Access Compliance Report

Public Rights-of-Way

(Curb Ramps)

Intersection ID: 28629	Main Street: DEARMON_RD	Cross Street: EAGLE_CREEK_DR	Location: S
ADA ID: 4FC1F1D24847	Ramp Type: Perp	Initial Pass/Fail: Fail	Overall Compliance: No
Severity Score: 21.25			
Codes/Mitigation Info/Possible Solution		Field Measurements/Component Compliance

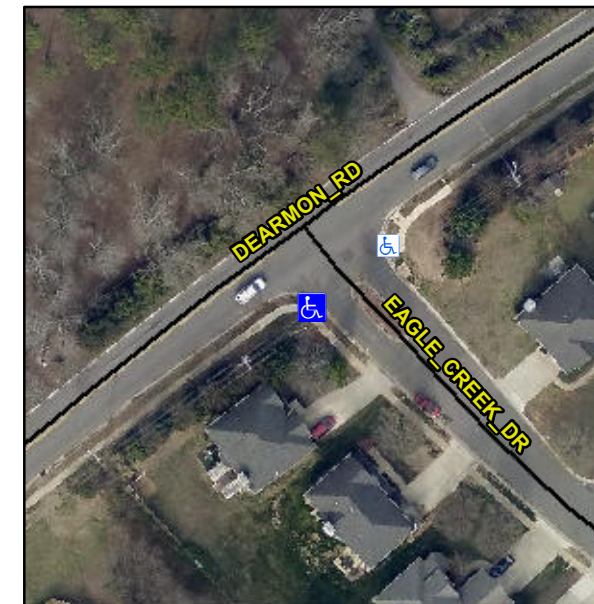
R304.5.1, R304.2.2

Compliance	Description	Data	Compliance	Description	Data
N/A	Ramp Length (in)	48.0	No	Ramp Slope (%)	8.8
No	Ramp Width (in)	46.0	Yes	Ramp XSlope (%)	2.0
N/A	Flare Type LT	N/A	N/A	Flare Type RT	N/A
N/A	Flare Slope LT (%)	N/A	N/A	Flare Slope RT (%)	N/A
N/A	Flare Traversable LT?	N/A	N/A	Flare Traversable RT?	N/A
N/A	Landing Length (in)	N/A	N/A	DWS Provided?	N/A
N/A	Landing Width (in)	N/A	N/A	DWS Contrast?	N/A
N/A	Landing Slope (%)	N/A	N/A	DWS Length (in)	N/A
N/A	Landing X Slope (%)	N/A	N/A	DWS Full Width?	N/A
N/A	Landing Curb? (Y/N)	N/A	N/A	DWS Offset (in)	N/A
N/A	Shared Landing?	N/A			
N/A	Gutter Ponding?	N/A	N/A	Gutter Slope (%)	N/A
N/A	Gutter Lip Ht (in)	N/A	N/A	Gutter X Slope (%)	N/A
N/A	Painted X Walk1?	No	N/A	Painted X Walk2?	N/A
	X Walk 1 Direction	To NE		X Walk 2 Direction	N/A
N/A	X Walk 1 Width (in)	N/A	N/A	X Walk 2 Width (in)	N/A
	X Walk 1 Slope (%)	4.1		X Walk 2 Slope (%)	N/A
	X Walk 1 X Slope (%)	0.0		X Walk 2 X Slope (%)	N/A

Remove & Replace Entire Ramp.
